USB Type-C ENGINEERING CHANGE NOTICE

Title: Fix Connection State Diagram - Sink with Accessory Support (SWAS) State Transition

Applied to: USB Type-C Specification Release 2.4, Oct 2024

Figure 4-14 Connection State Diagram: Sink with Accessory Support

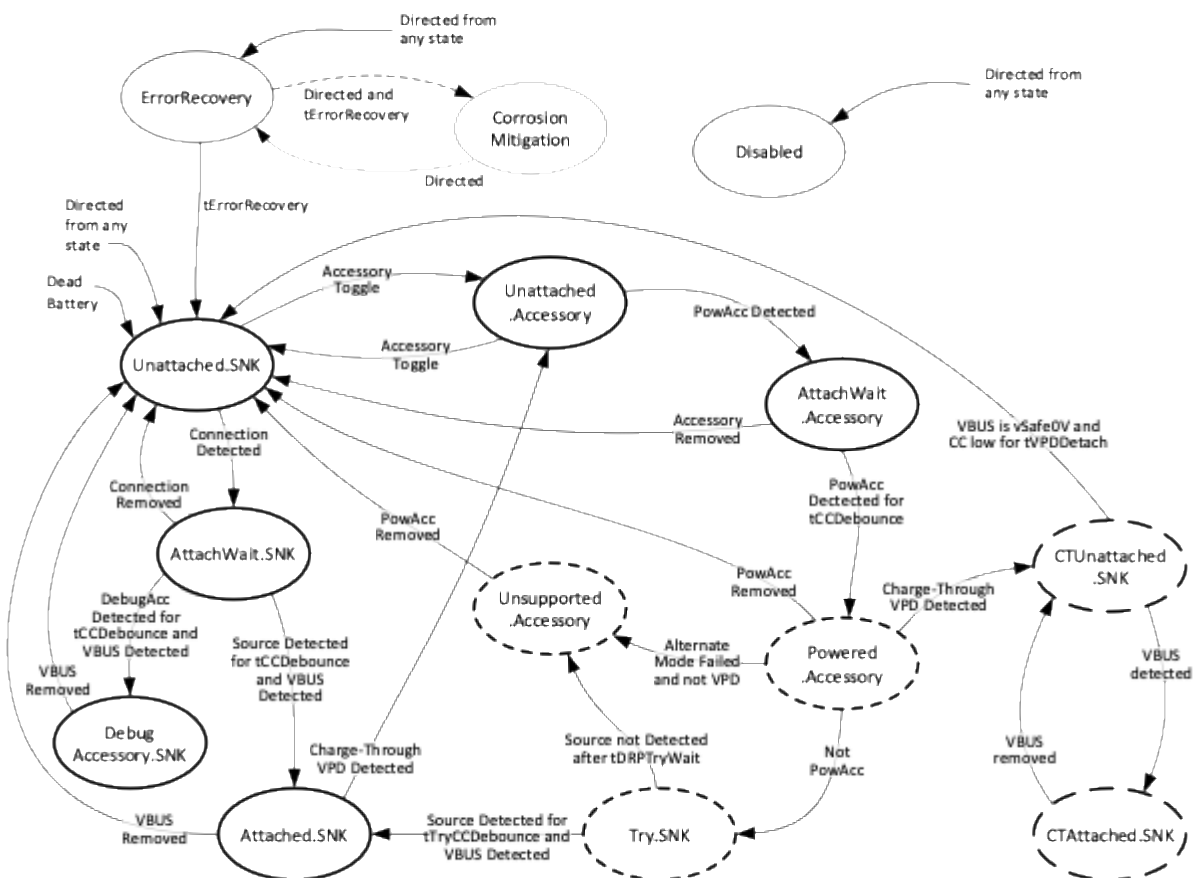
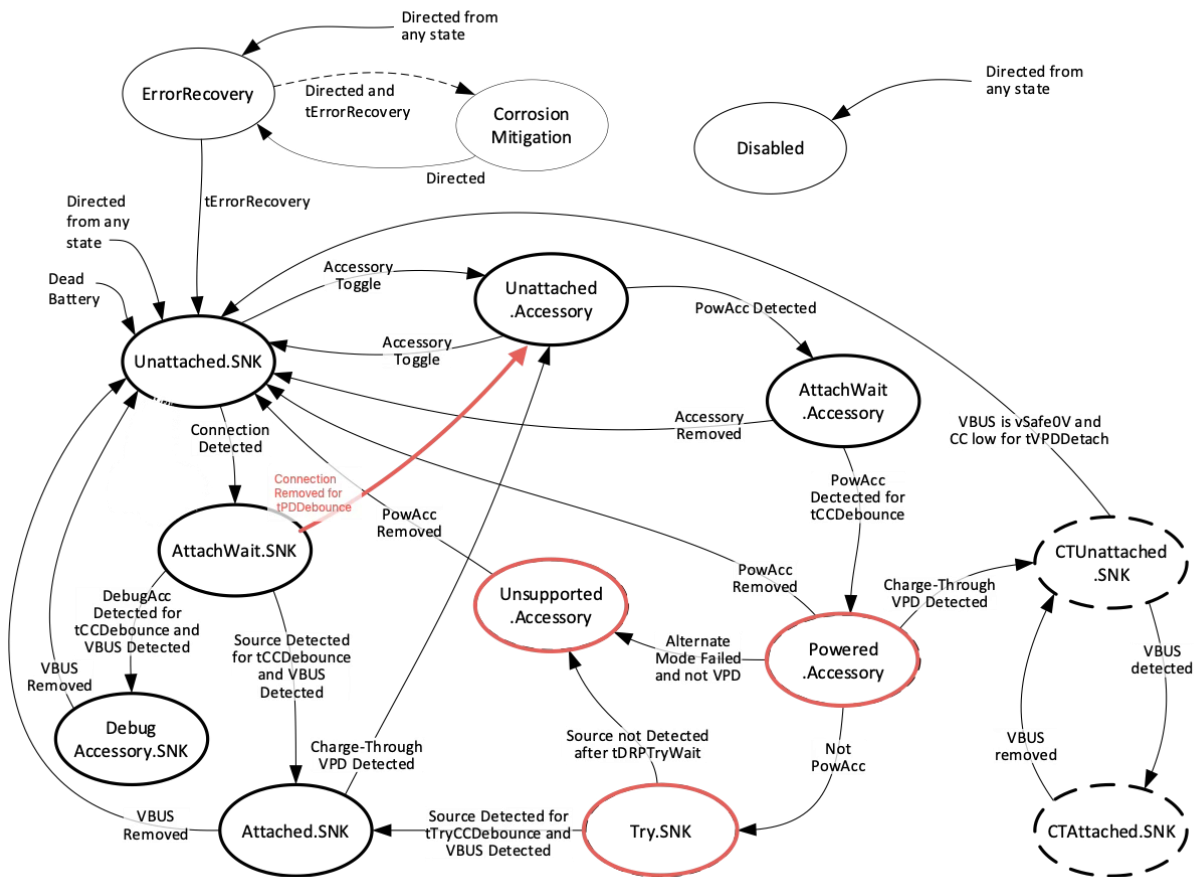
(a). Section 4.5.2.1, Figure 4-14, Connection State Diagram: Sink with Accessory Support, Page 174

Diagram shows state transition arc:

AttachWait.SNK → Unattached.SNK (on "Connection removed" event)

Three states shown with dashed outline (indicating optional states):

- Powered.Accessory
- Try.SNK
- Unsupported.Accessory

Diagram shows state transition arc:

AttachWait.SNK → Unattached.Accessory (on "Connection removed" event)

Three states shown with solid outline (indicating required states):

- Powered.Accessory (with corrected naming)
- Try.SNK
- Unsupported.Accessory
